SUBJECT: Forwards updated response to deviations noted in EOPs Insp
 Rept 50-397/91-27, satisfying commitment made in 940425
 response to Insp Rept 50-397/94-01.

December 30, 1994
GO2-94-292

Subject: **WNP-2, OPERATING LICENSE NPF-21
NRC INSPECTION OF WNP-2 EMERGENCY OPERATING PROCEDURES
(NRC INSPECTION REPORTS NO. 91-27 AND 94-01)**

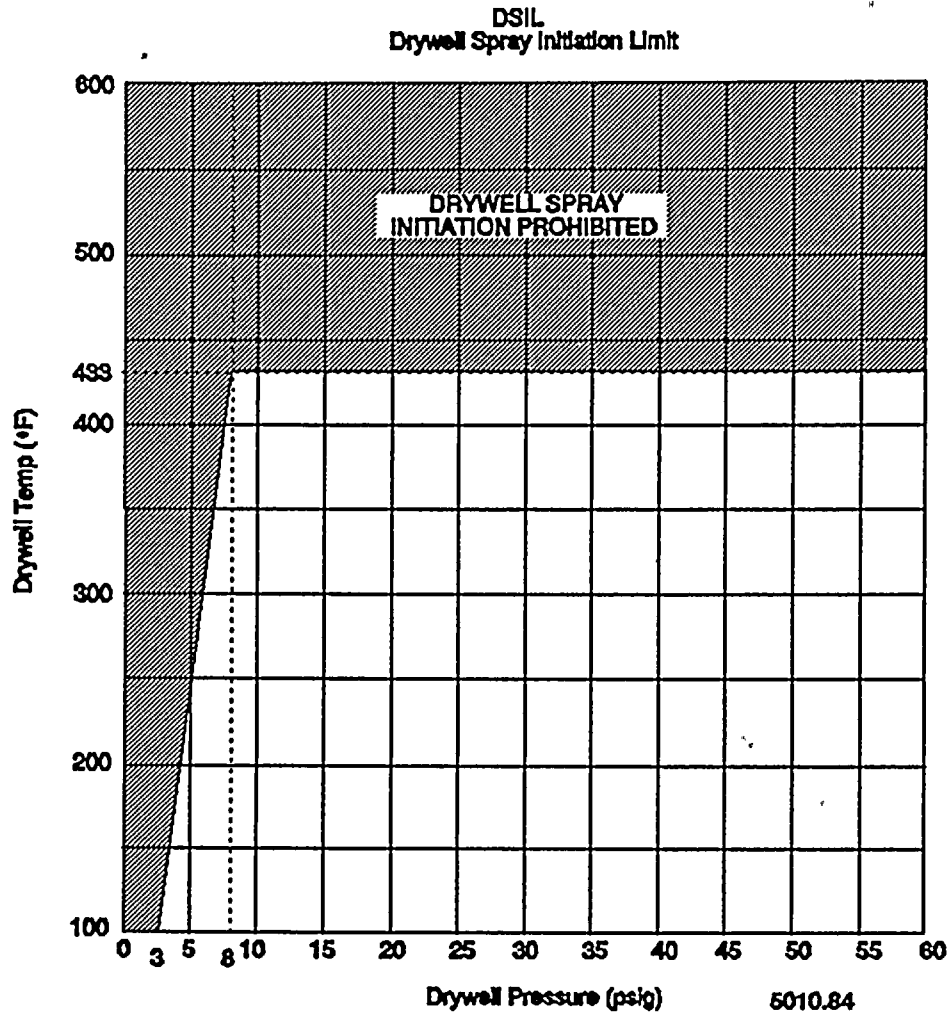
The BWROG EPG Appendix C Drywell Spray Initiation Limit (DSIL) worksheet (WS-3) resulted in a curve for WNP-2 which prohibits the initiation of drywell sprays under drywell pressure-temperature conditions at which the WNP-2 licensing basis assumes their use. The DSIL calculation was modified to overcome this conflict with the Design Basis. WNP-2 also intends to modify the curve further. The DSIL curve resulting from this additional modification is addressed as the "proposed" WNP-2 DSIL curve in the following discussions. (Note: Neither the Basis nor the intent of the EPG was violated in taking this deviation.)

No adverse comments. There was considerable discussion with the NRC on this topic. The primary thrust of the discussion was to clarify both the EPG basis for the curve as well as the Supply System's deviation to the curve to accommodate its drywell-to-wetwell bypass leakage event. The NRC indicated they would contact the Supply System if they had further questions on this deviation.

The BWROG methodology defines a variable " $T_{dw-min}(P_{dw})$ " which is a line describing the drywell temperature as a function of pressure assuming that all the nitrogen originally in the containment has been transferred to the drywell and is at 0.0% humidity. This line provides an upper bound to the pressure in the drywell for all isolated containment situations if the drywell is completely dry.

For cases in which the humidity is 100%, a line may be drawn on the same graph which defines the minimum possible pressure in the containment as a function of temperature, by assuming that all of the nitrogen has instead been transferred to the wetwell. This line is simply the saturation line for water vapor.

The figure shows these two curves as well as the DSIL which is developed from the generic guidelines. On the right side of the curve is an area where the water vapor saturation line is above the DSIL. This is also the region where WNP-2 licensing basis calculations have assumed that the containment sprays would be used in a LOCA type accident.

Based on this position of the EPC, WNP-2 intends to adopt the (plant-specific) DSIL curve identified as the "Proposed" WNP-2 DSIL Curve in the figure in Section O.6, following formal documentation of the supporting WNP-2 calculation. The deviations and the justifications for the deviations involved in developing this curve are presented in section O.6 below.

The deviations from the EPG, Revision 4 involved in developing the proposed WNP-2 plant-specific DSIL curve are as follows:
